Access Compliance Report

Public Rights-of-Way

(Curb Ramps)

Intersection ID: 21423	Main Street: BURNT_MILL_RD	Cross Street: GONEAWAY_RD	Location:	NE
ADA ID: F017041F026C	Ramp Type: BlendTrans2	Initial Pass/Fail: Fail	Overall Compliance: No	Severity Score: 25
Codes/Mitigation Info/Possible Solution		Field Measurements/Component Compliance

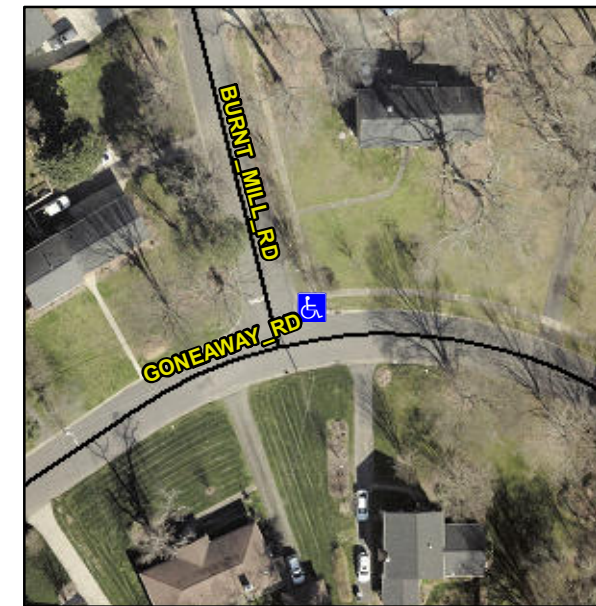
Remove & Replace Curb Ramp With Two New Directional Ramps or Equivalent.

Not Found, R304.5.3

Compliance	Description	Data	Compliance	Description	Data
N/A	Ramp Length (in)	68.0	Yes	BlendTrans Slope (%)	4.1
Yes	Ramp Width (in)	48.0	No	BlendTrans XSlope (%)	8.7
N/A	Flare Type LT	N/A	N/A	Flare Type RT	N/A
N/A	Flare Slope LT (%)	N/A	N/A	Flare Slope RT (%)	N/A
N/A	Flare Traversable LT?	N/A	N/A	Flare Traversable RT?	N/A
N/A	Landing Length (in)	N/A	N/A	DWS Provided?	N/A
N/A	Landing Width (in)	N/A	N/A	DWS Contrast?	N/A
N/A	Landing Slope (%)	N/A	N/A	DWS Length (in)	N/A
N/A	Landing X Slope (%)	N/A	N/A	DWS Full Width?	N/A
N/A	Landing Curb? (Y/N)	N/A	N/A	DWS Offset (in)	N/A
N/A	Shared Landing?	N/A			
N/A	Gutter Ponding?	N/A	N/A	Gutter Slope (%)	N/A
N/A	Gutter Lip Ht (in)	N/A	N/A	Gutter X Slope (%)	N/A
N/A	Painted X Walk1?	No	N/A	Painted X Walk2?	No
	X Walk 1 Direction	To W		X Walk 2 Direction	To S
	X Walk 1 Width (in)	N/A		X Walk 2 Width (in)	N/A
	X Walk 1 Slope (%)	1.5		X Walk 2 Slope (%)	8.1
	X Walk 1 X Slope (%)	6.0		X Walk 2 X Slope (%)	4.1

N/A	Ramp inside XWalk1?	N/A	N/A	Ramp inside XWalk2?	N/A
	Road Slope (%)	6.0		Clear Space?	N/A
	Road X Slope (%)	7.6	N/A	Clear Space to XWalk (in)	N/A
N/A	Any Obstructions?	N/A	N/A	Storm Grate/Utility Hazard?	N/A
	Obstruction Type			Storm Grate/Utility Type	
		N/A			N/A
			Yes	Surface Condition? (G/P)	Good
			No	Curb Slope (%)	13.1
